PCN#:	2024-002		SS CHANGE NO	TIEICATIC) NI		
MCN#	S2024-001, S2024-012	PRODUCT/PROCESS CHANGE NOTIFICATION					
Date:	23.8.2024	Manufacturing location influenced:	BU	Kranj			
Contact:		Gašper Albinini, sales manager	, gasper.albinini@iskra.eu	Attachments:	yes

WM3M4, WM3M4C

DESCRIPTION, PURPOSE AND INFLUENCE OF CHANGE

Attachment 1:

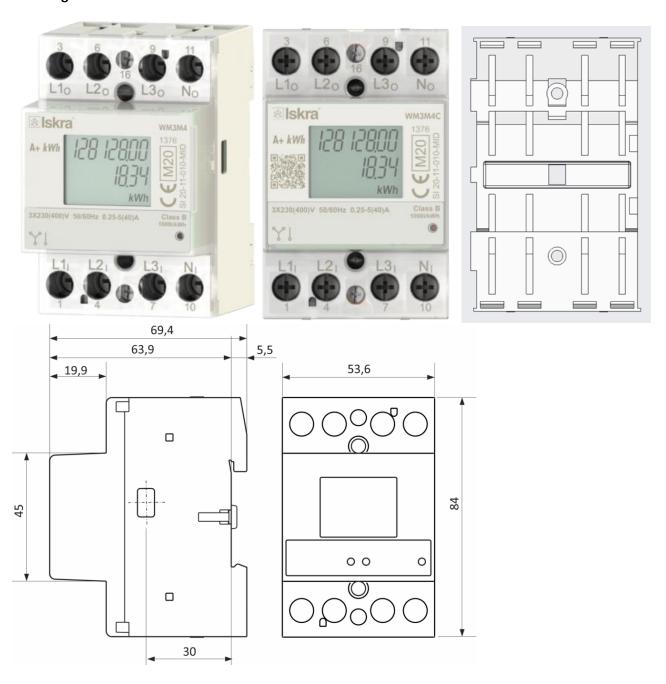
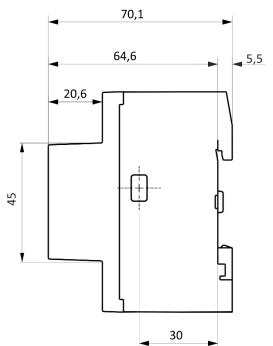
Housing Correction

Bottom part: The correction is proposed due to transition to an automated assembly – the insertion of springs and the need for a new tool. Effect on basic product functionality: **No impact.**

Middle part: On the middle part of housing walls had to be adjusted to be compatible with the new bottom part of housing. To prevent possible deformations during riveting, mounting area for top part of housing was added to ensure precise and improved position. Effect on basic product functionality: **No impact.**

Top part: Made with new technology. Due to change of technologies, the need for stickers and the process of screen printing will be eliminated. Effect on basic product functionality: **No impact.**
